Service Campaign 62-01

AFFECTED: Certain 2013 Winnebago Adventurer, Journey, Tour and Itasca Suncruiser, Meridian and Ellipse model motor homes.

SUBJECT: Roof A/C Mounting Verification

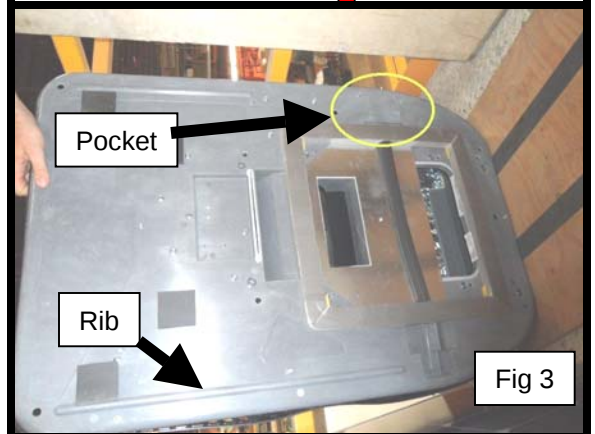
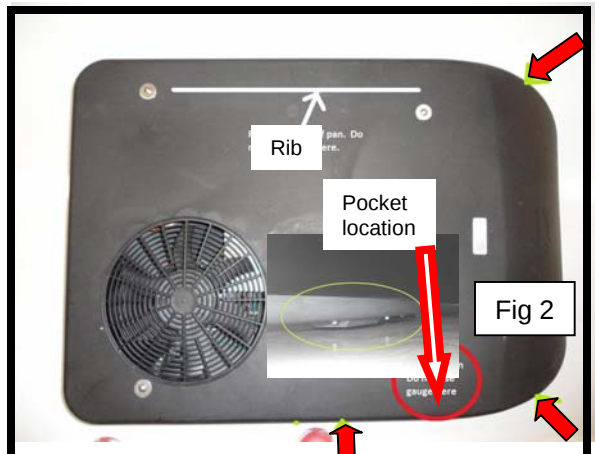
1. Construct wood gauge to specifications in (fig 1).

2. Use gauge (fig 1) at front right, front left corners and the middle of the right side areas indicated by arrows (fig 2).

Note: Make sure gauge does not interfere with rib on bottom of pan on left side or pocket on right side. Also pocket should not contact roof (fig 3).

The 7/16" gauge should slide under the pan in all three test points and the 3/4" gauge should not.

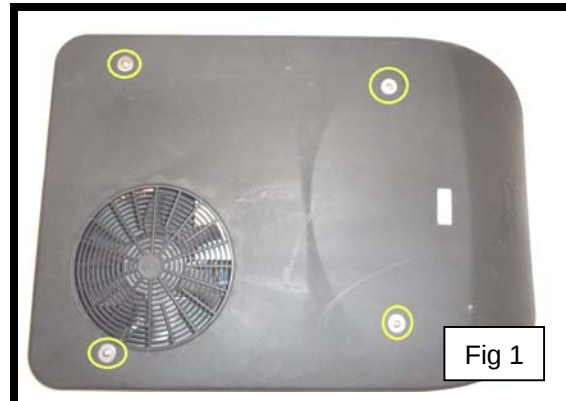
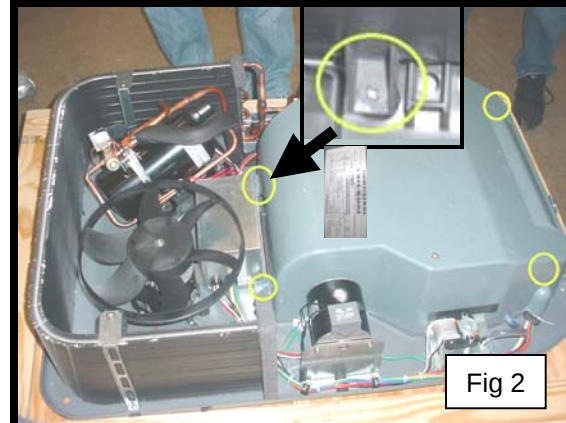
1. Remove the four (4) bolts securing outer cover and remove cover (fig 1).

2. Remove inner cover. Inspect attachment tabs for cracks (fig 2). If cracked, a washer should be added when cover is reinstalled. If tab has broken off a new cover will be needed. Order cover p/n 183061-01-700.

Note: If cover is replaced, record model and serial number on new cover from original cover label.

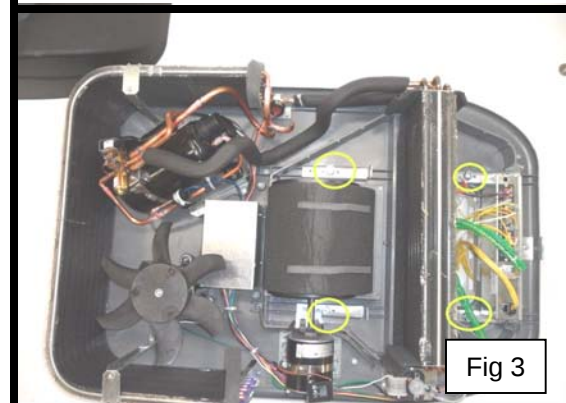
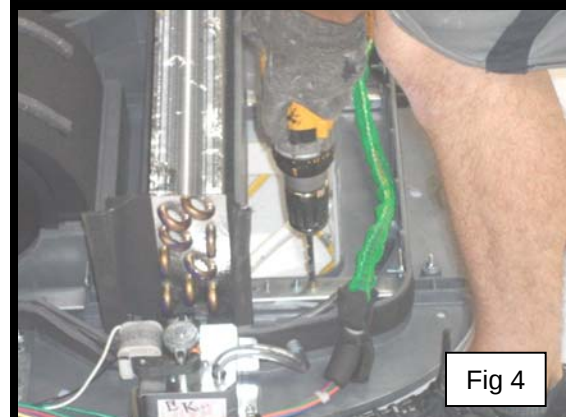
3. Remove the four (4) lag bolts w/springs attaching AC unit to the roof (fig 3).

4. Use 1/4" bit and drill out the four (4) Riv-Nuts. The Riv-Nuts need to be drilled out so they won't stop lag bolts from fully seating AC unit on roof during reinstallation (fig 4).

Note: If the 7/16" gauge verification failed at any location, it is too tight. Follow Seal Replacement (step 5). If it passed the 7/16" gauge verification at all locations but failed the 3/4" gauge verification, it is too loose. Move to step 6.

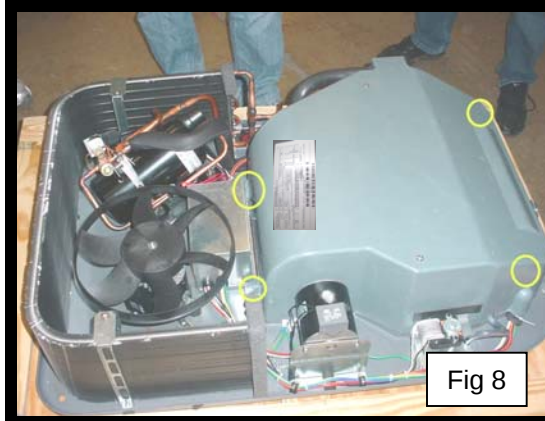
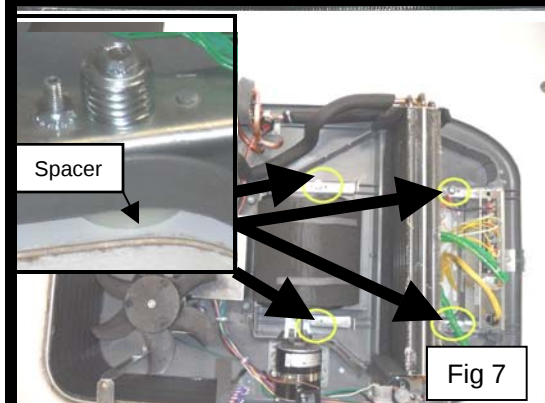
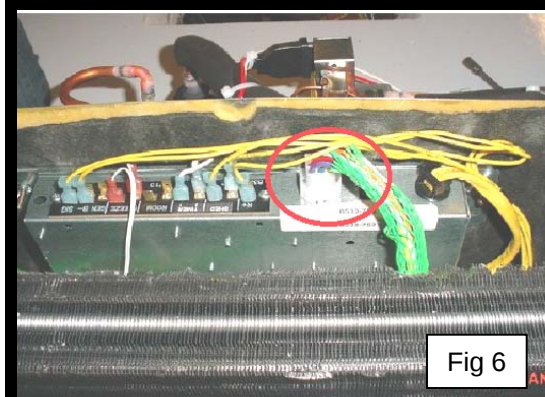
Remove the outer seal (the inner seal can remain intact) (fig 5).

Reconnect harness plug into the AC control box (fig 6).

6. There should be one (1) spacer p/n 178426-01-000 under each of the two (2) front mounting locations.

Reinstall lag bolts w/springs, washers and tighten just to the point where the springs are compressed (fig 7) .

7. Reinstall inner cover using washer if mounting tab is cracked. Replace inner cover (fig 8) if tab is broken off. Remember to record model and serial number on the new cover as noted in step 2. Reinstall outer cover with four (4) original bolts and washers.
